Lumberton Loop Feasibility Study

Advisory Committee
Meeting #2

September 28, 202 @ 11 AM (Town Hall &/or Virtual)

Residential North

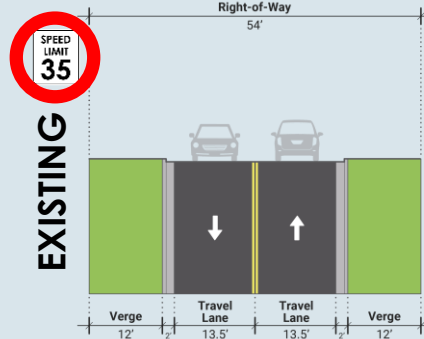
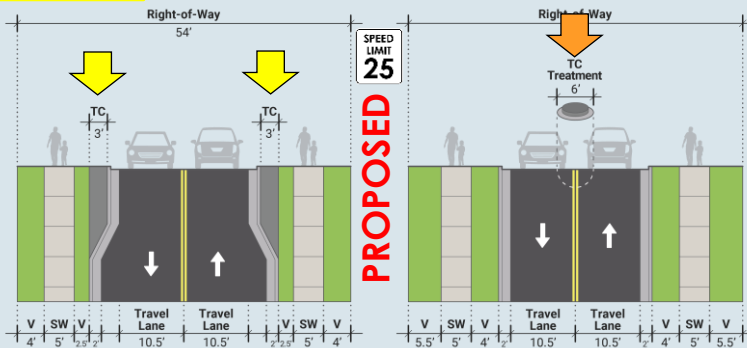
- City agrees with Section 3 traffic calming strategies. Demonstration projects may be good opportunity to 'test-fit' some concepts.
 - City would like to consider alternative alignment(s) along 15th Street – Elm Street into Downtown, to evaluate the benefits or constraints – Stantec to include this within the Evaluation Matrix options
